RE: DA2022/1915 – 29 WANDEEN ROAD, CLAREVILLE
PROPOSAL: ALTERATIONS & ADDITIONS TO A DWELLING HOUSE INCLUDING A SWIMMING POOL

I refer to Council's correspondence dated 19 January 2023 and on behalf of Ms Patricia Quirk, I am pleased to offer the attached revised architectural plans prepared by Vanessa Miles Design & Draft, Sheets A00 – A22, Revision 5 which we believe successfully respond to the issues raised in your assessment.

Fig 1: Extract from architectural plans to note comparative reduction in the extent of the breach of the existing maximum height and existing breach of the building envelope control

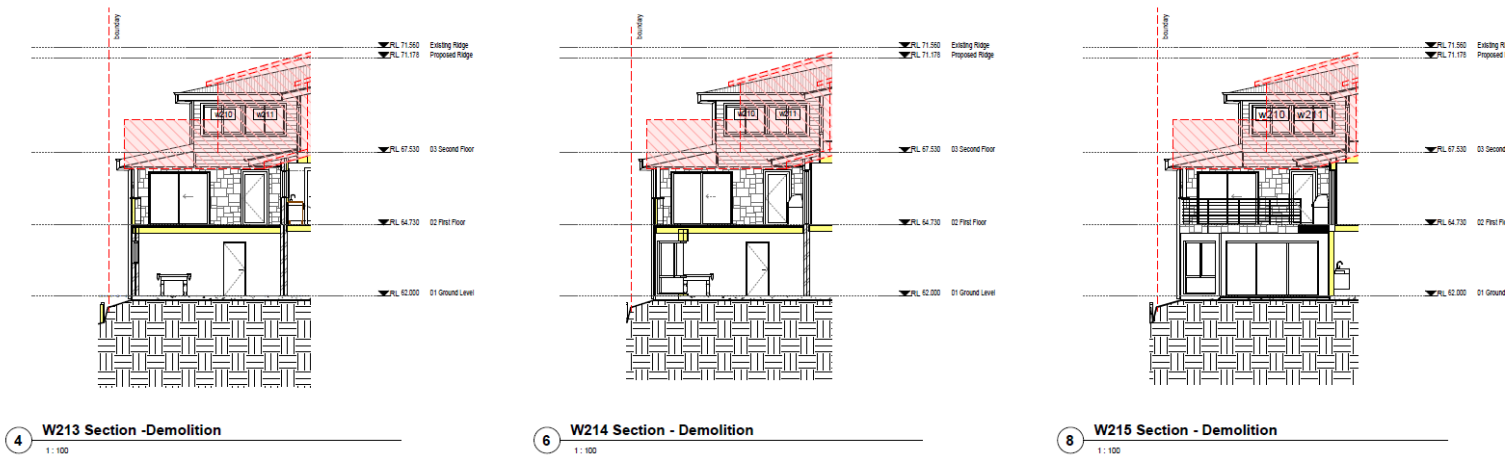
As previously discussed, the proposed amendments will reduce the extent of the building envelope breach and as indicated in the figure below, the removal of the existing gable end and the reduction in the overall height of the building as a result of the proposed works, the proportion of the building which breach the building envelope control is significantly improved as a result of the works. Any further movement of the western wall of the upper level to the east would not result in any change in the overall calculable building height, as the height is depicted from the existing ground floor level which is level throughout the majority of the western half of the proposed floor plate.

As we believe that the proposed amendments respond positively to Council’s concerns, we ask that the application be considered on its merits in relation to the building envelope control.
